FAUNTLEROY WAY APARTMENTS | DESIGN RECOMMENDATION

April 6, 2017

RESPONSES TO EARLY DESIGN GUIDANCE

SUMMARY OF EDG BOARD RECOMMENDATIONS

TYPICAL LIVE WORK PLAN

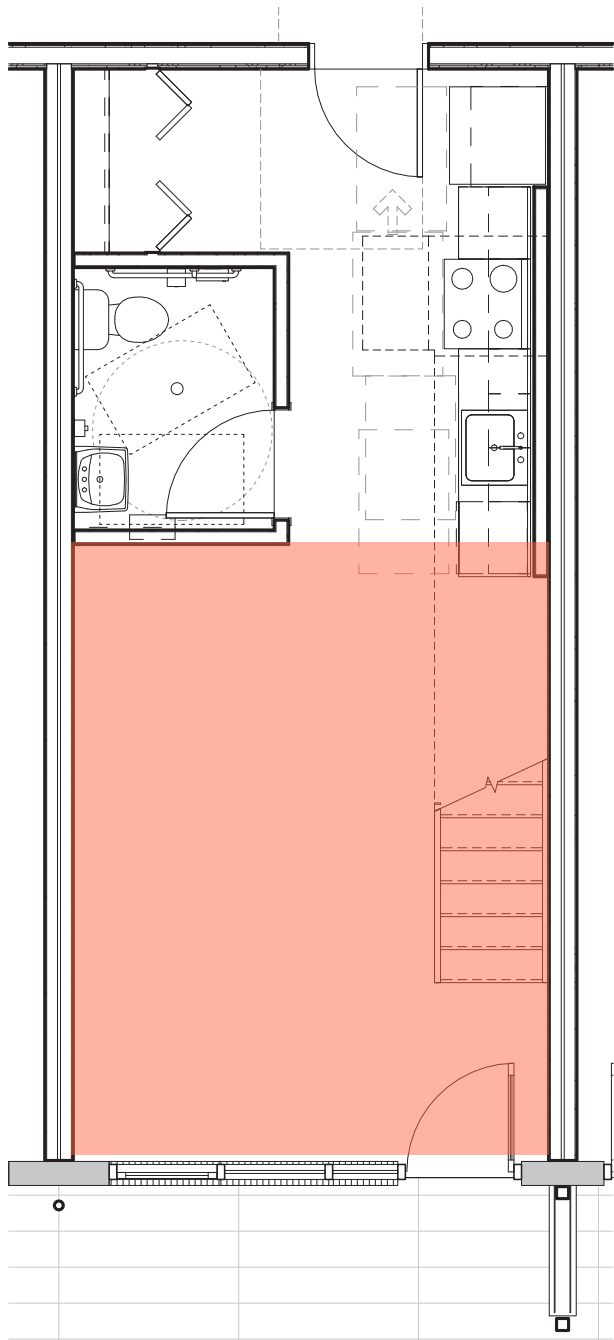
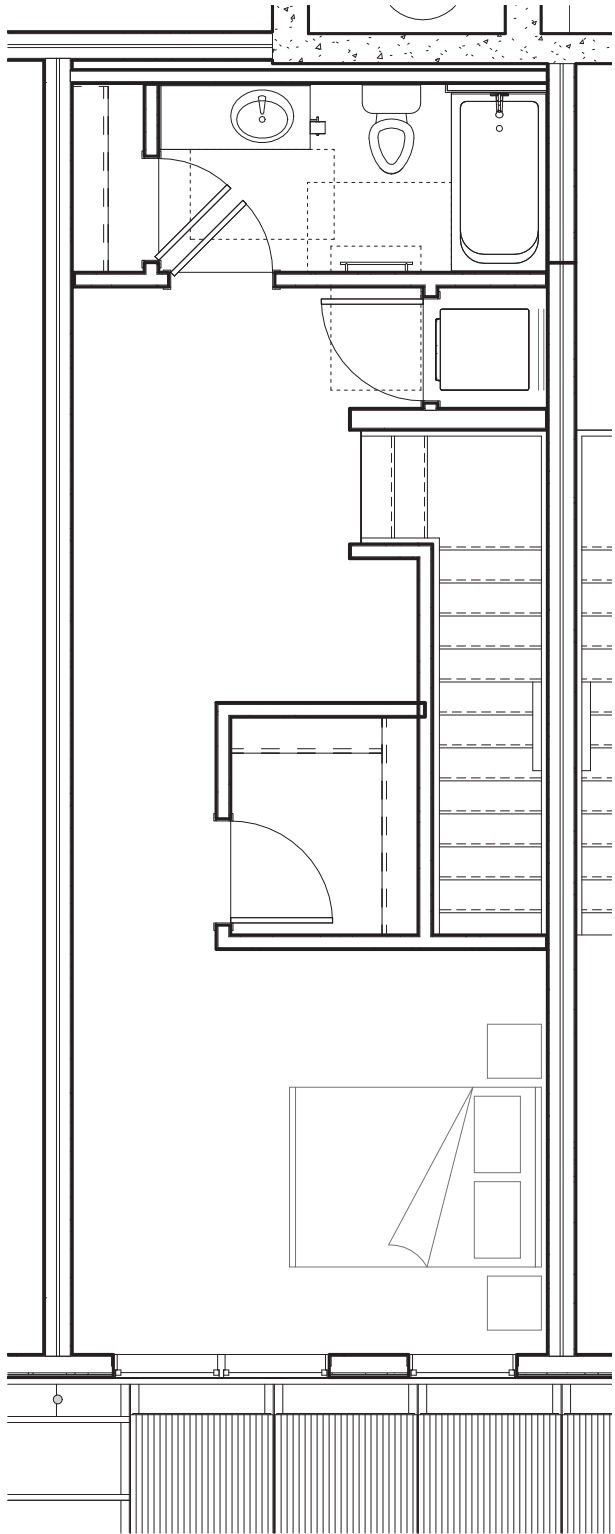
2b. Incorporate ways to activate the ground floor to *achieve a sense of commercial activity through interior programming and design of the setback.* Consider separating the live portion from the work portion as much as possible to achieve this.

- A sense of commercial activity is promoted along the base with the generous setback provided for a secondary public space for pedestrians and residents to interact
- Widened sidewalks at grade and along 'dock' create spaces for live-work units to spill out their uses - an extra layer for ancillary activities such as sidewalk vending and seating
- Large storefront windows create visual interest for pedestrians and activate the commercial walkway
- Signage is integrated with the building for commercial uses

- Residential uses are located on second level, with minimal accessible uses on ground level oriented away from front entry

SECTIONS THROUGH LIVE-WORK ENTRIES AND SIDEWALKS AT FAUNTLEROY AND EDMUNDS

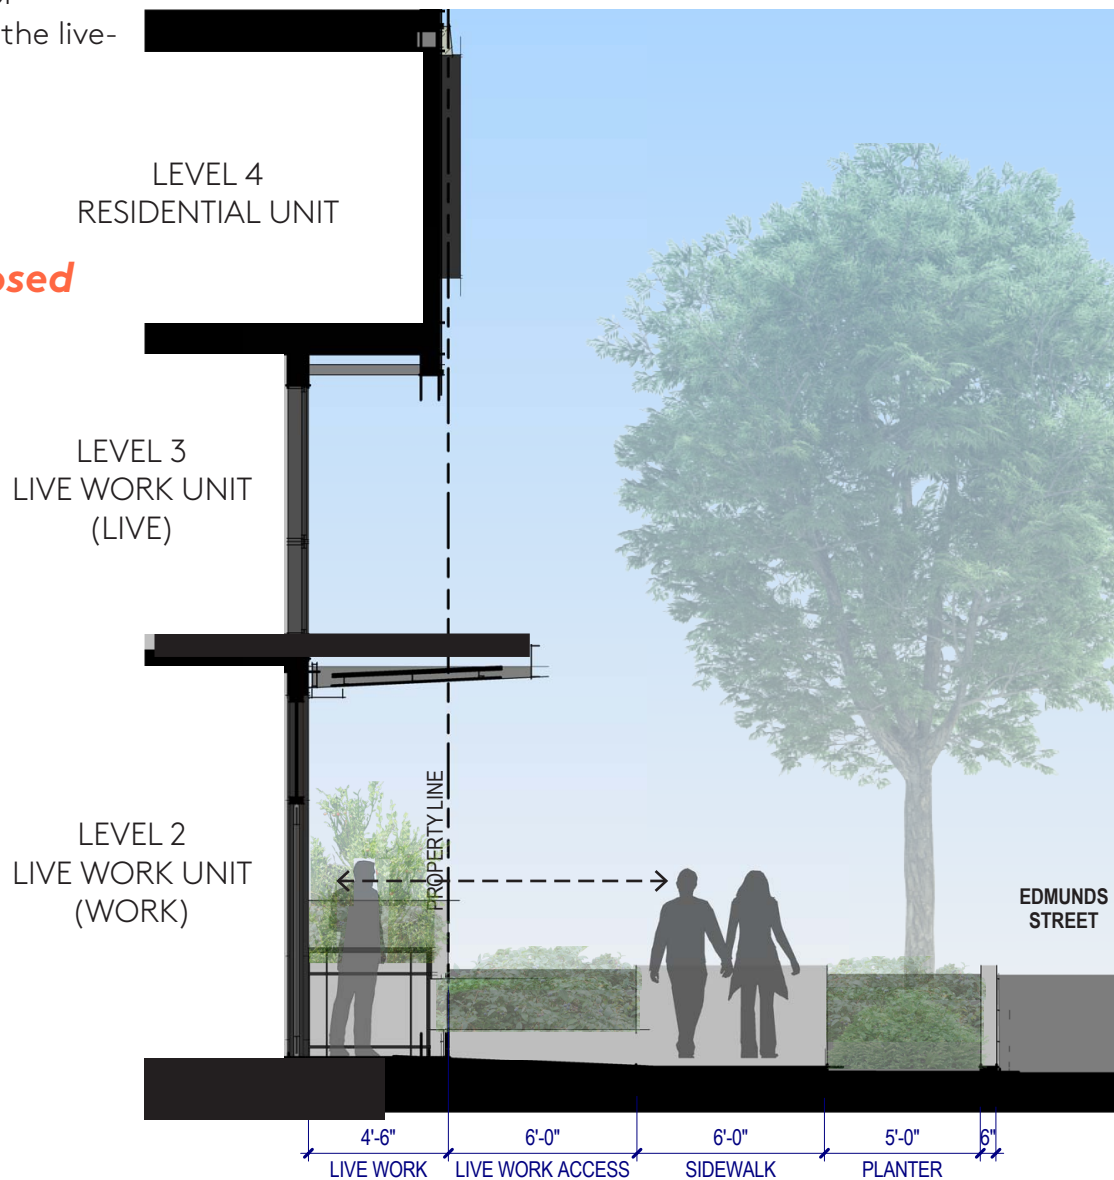
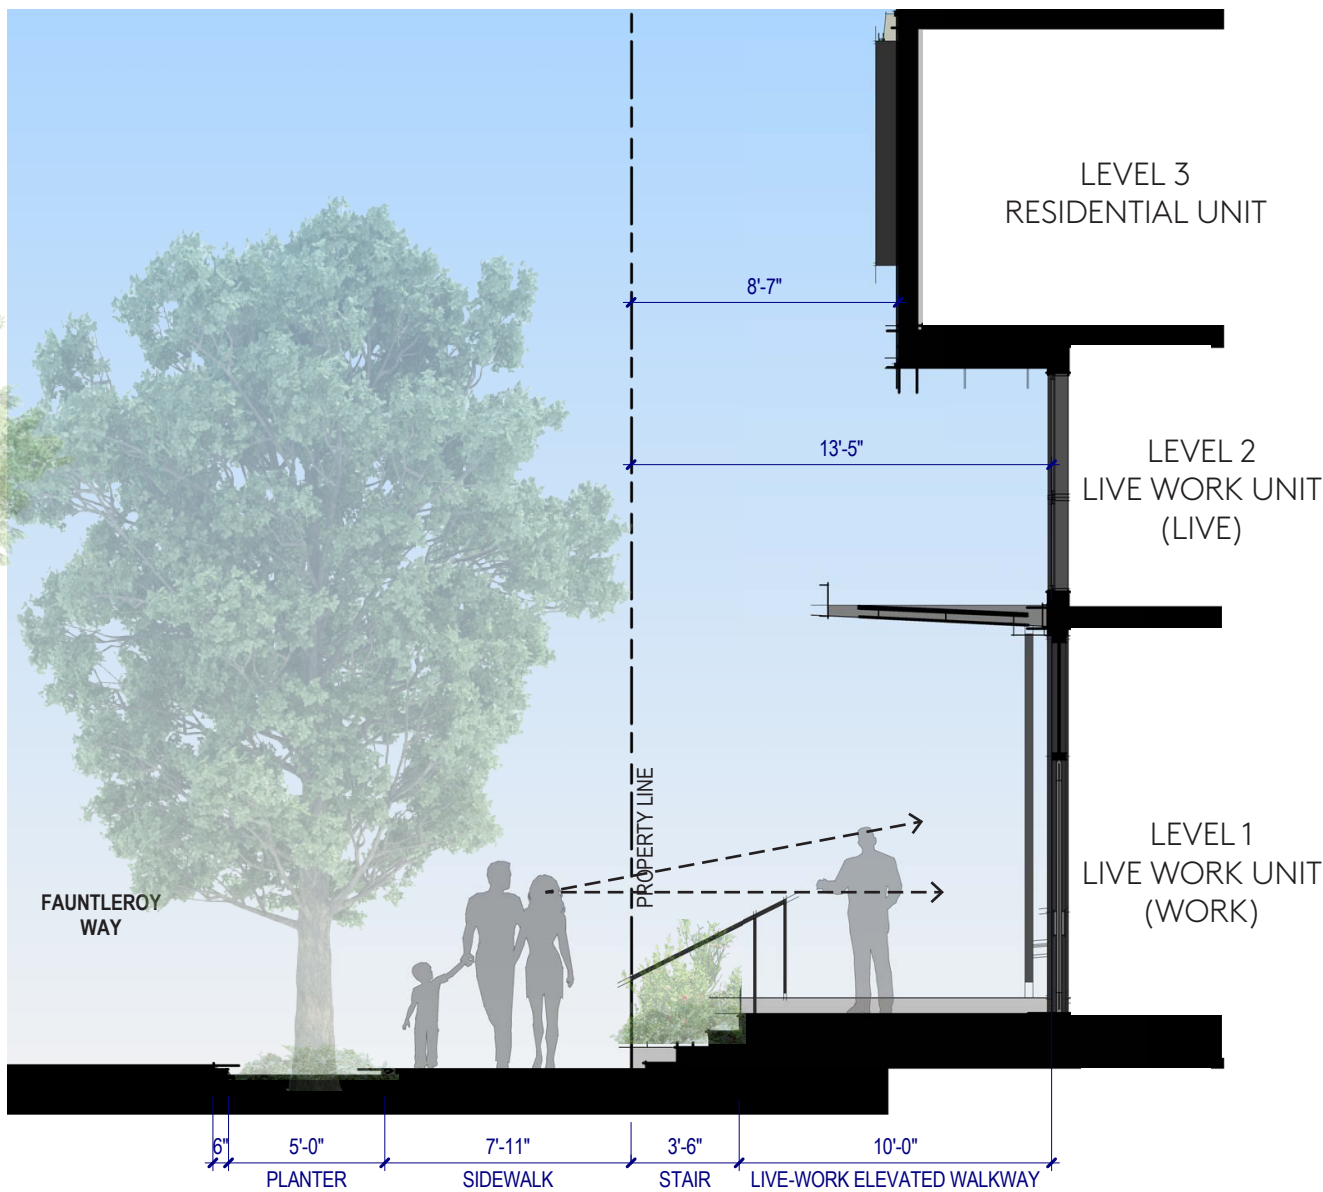
2e. Views from the sidewalk to the raised live-work patios should be unobstructed with any landscaping in the raised concrete planters maintaining visibility and porosity.

- Planting plans have been redesigned to allow views from the sidewalk to the raised live-work units to be unobstructed for visibility into commercial portions of the live-work units

- Setbacks maintained from EDG meeting
